Wayne Wright, W5XD  
Directional Coupler

Rev 1.0  
10/15/2023

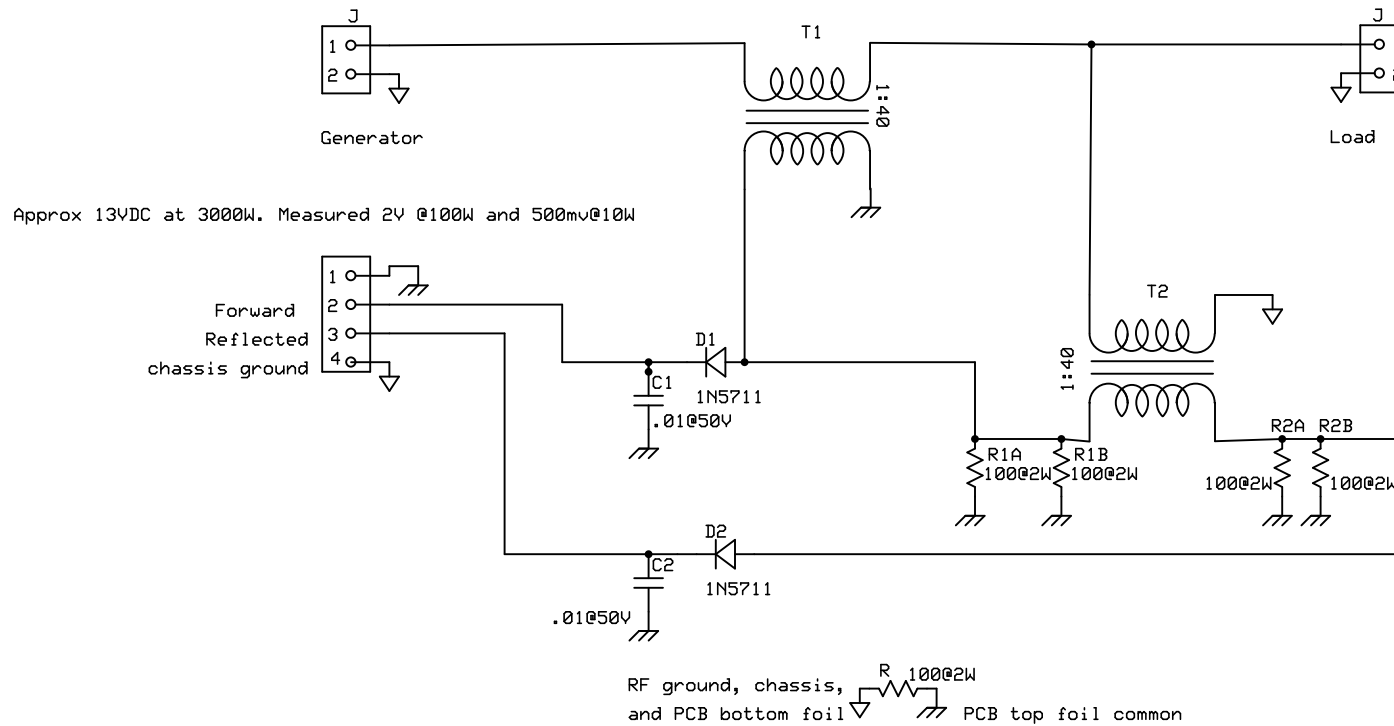
Exception: REV01 of the PCB has the 40T holes placed such that Forward and Reflected are reversed at the output

Fix this either by:

- a) reverse one of the transformer's wires to their opposite holes on the PCB OR
- b) wind the second transformer in the opposite direction when you construct it.
